Preliminary Consultation
MONTGOMERY COUNTY HISTORIC PRESERVATION COMMISSION
STAFF REPORT

Address:	3806 Williams Lane, Chevy Chase	Meeting Date:	8/14/2024
Resource:	Master Plan Site #35/076 Williams-Wirgman House	Report Date:	8/7/2024
Applicant:	Phil Leibovitz (Luke Olson, Architect)	Public Notice:	7/31/2024
Review:	Preliminary Consultation	Staff:	Laura DiPasquale
Proposal:	Partial demolition, construction of new two-story rear addition, new detached accessory structure

Figure 2: Elevations and renderings (left) from the submission packet are missing the corbelled chimney seen in the photographs (right).

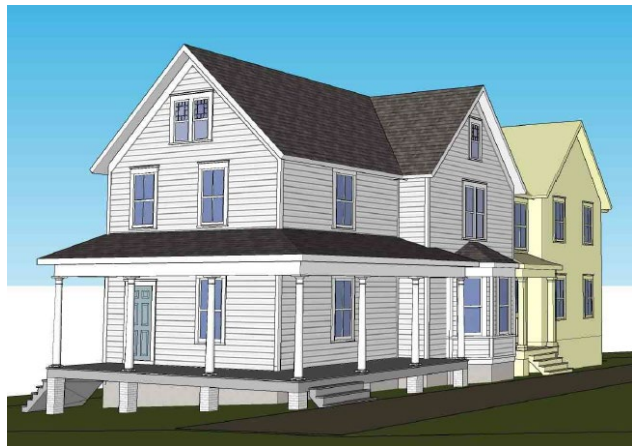
For the most part, the application proposes to retain the historic character of the property, with removal of historic materials limited to the rear wall and substantial portion of the rear roof slope, satisfying *Standard 2*. Staff notes that the drawings and renderings do not show the historic corbelled chimney on the west elevation, but that this character-defining feature should be retained and preserved as part of any redevelopment of the property, and shown on subsequent elevation drawings.

Figure 3: A secondary corbelled chimney is visible on the east elevation of the existing building (right), but not shown on the drawings or renderings in the submission. While this chimney also appears to be original, it is not as character-defining of the property as the larger chimney on the west elevation.

Figure 4: Site plan and renderings showing the proposed rear addition and accessory structure (shaded in light yellow).

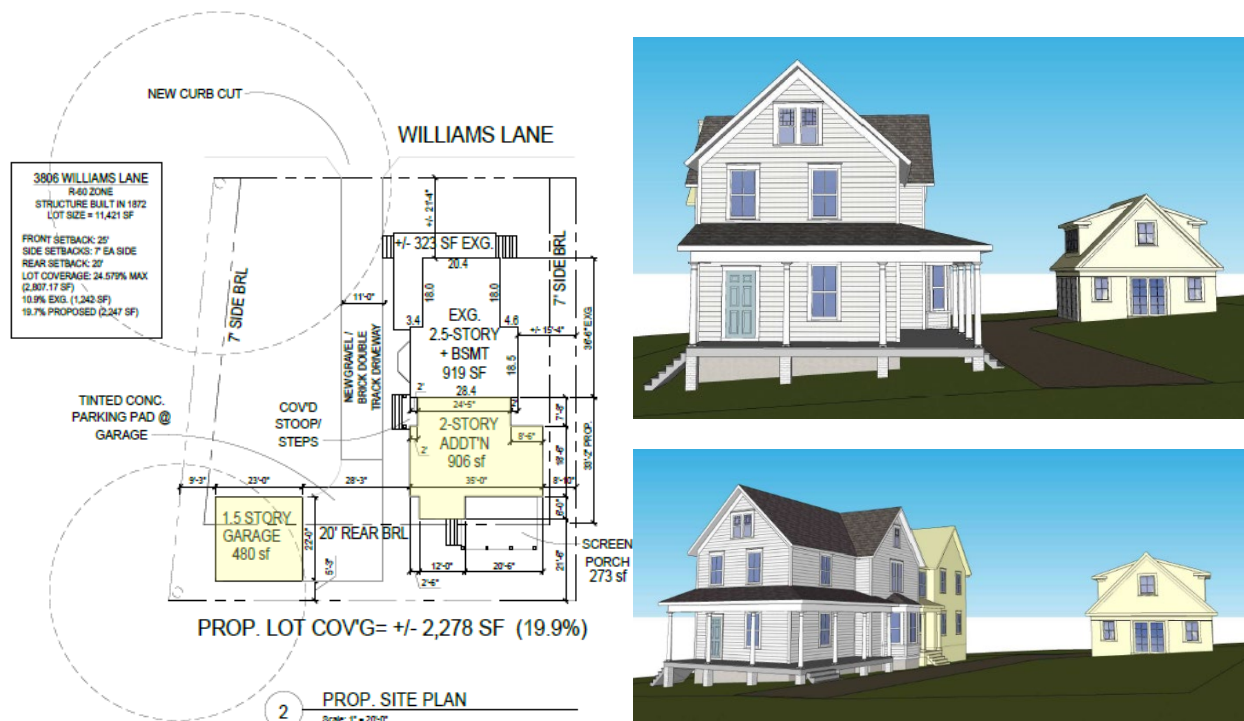
The proposed garage has a footprint of 20 by 23 feet and features a front gable roof with large, shed dormers on the sides. The garage would be set back over 80 feet from Williams Lane, and accessed by a new curb cut and driveway, which the applicant has identified as gravel or brick double-track leading to a tinted concrete parking pad at the garage. The driveway would be immediately adjacent to the house, leaving a large portion of the yard intact. Fencing is not identified on the application. The site plans show two large existing trees, which the designation of the property in the *Master Plan Amendment* identify as character-defining features of the property. No formal tree survey, protection plan or arborist reports were submitted as part of the preliminary consultation application, but a survey at a minimum and potentially a tree protection plan will be required when submitting for the HAWP.
